THE TOPEKA LANDMARKS COMMISSION MEETING

A G E N D A

Thursday, April 14, 2016

Topeka Landmarks Commission
Certified Local Government
Certificate of Appropriateness
National Historic Register Project Review
TOPEKA PLANNING DEPARTMENT

DEMO NOTES A1

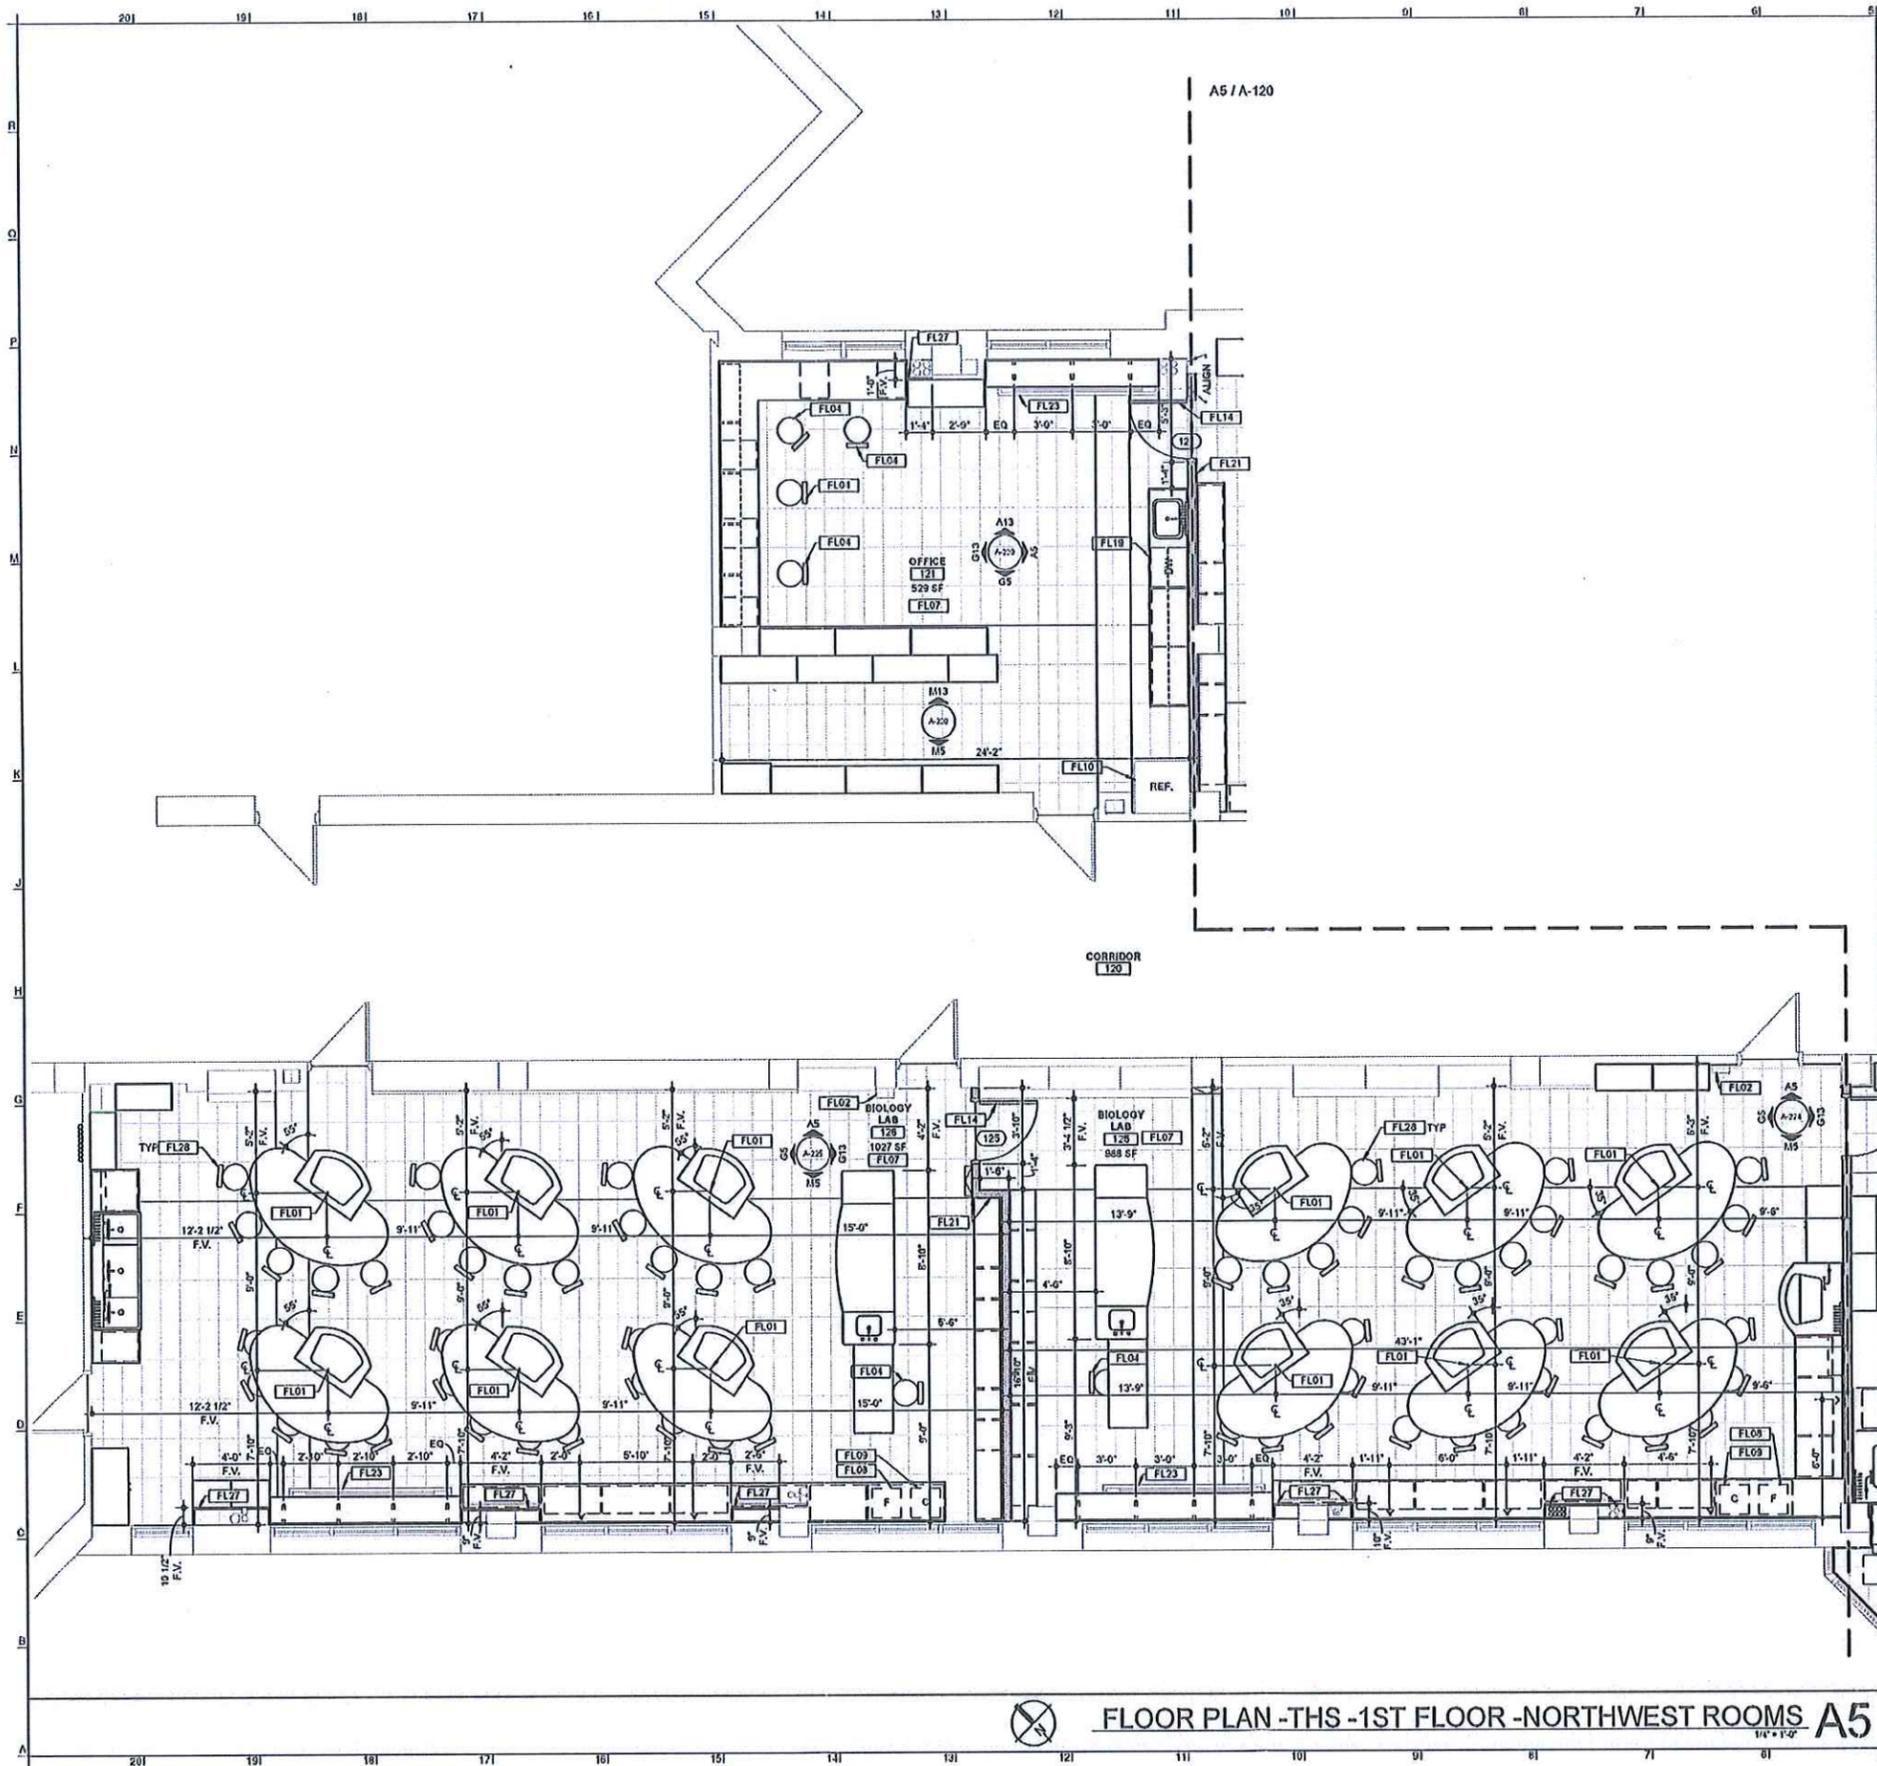
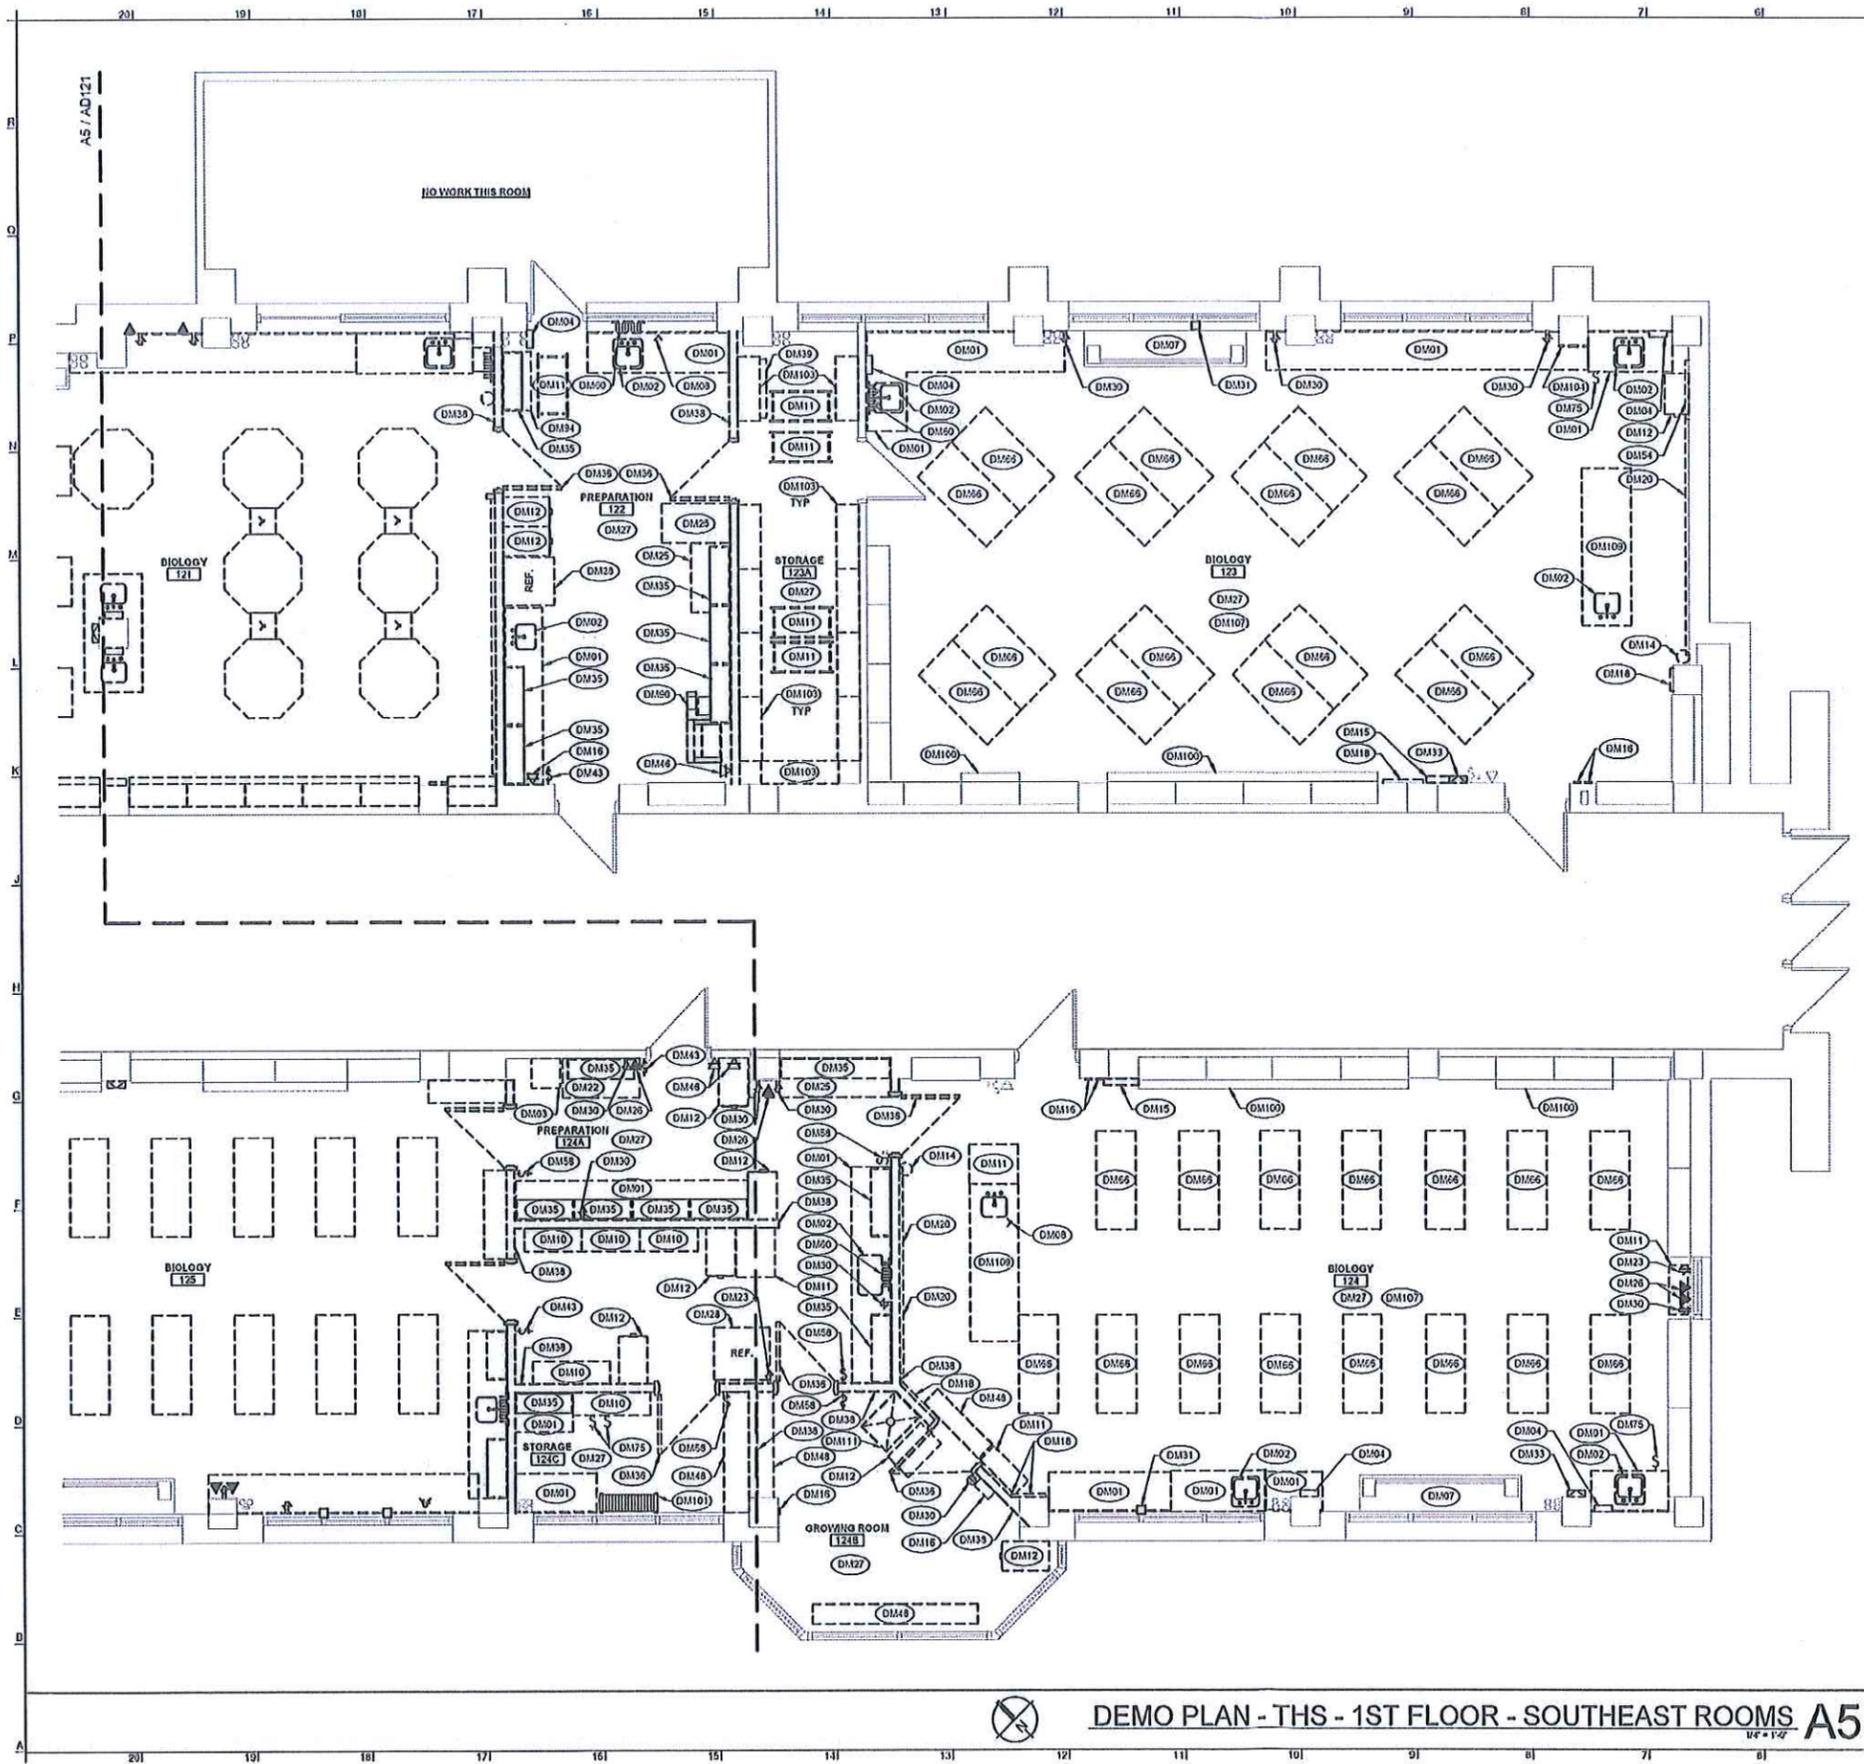
Analysis – One portion of this project will remove an original wall between two classrooms, and construct its replacement approximately 15 feet to the east. The result of this modification will be the slight reduction in size of one classroom, and the expansion of its adjacent classroom. Within the confines of this specific project, several original walls have previously been removed to accommodate student and faculty needs.

A second portion of this project is to remove an original wall between classrooms, and construct a new wall a distance of approximately 15-feet to the west from its current location. This removal and replacement will result in two classrooms of equal size and function, and will also convert the entirety of a bay window from a storage space to useable classroom space.

Following this guidance, the walls proposed for removal, and the construction of their replacements are located within the interior of classrooms, and are not visible from the more public space of the primary hallway, nor are they visible from any exterior entrance to the building. Additionally, the removal and replacement of each wall will avoid any substantial modification to the historic character of all affected classrooms. While it is recognized that this project does remove two original walls of the structure, this action lies within an area of secondary concern for the preservation of the building’s overall historic character, as suggested by the *National Park Service Incentives - Guide to the Federal Historic Preservation Tax Credit Incentives Program for Income Producing Properties Briefs for Historic Building Interiors*.

Planning Staff Recommendation: Based upon an evaluation of the project according to the Secretary of the Interior's Standards for Rehabilitation, it is Staff's finding that the proposed project will **NOT** damage or destroy the historical integrity of Topeka High School.
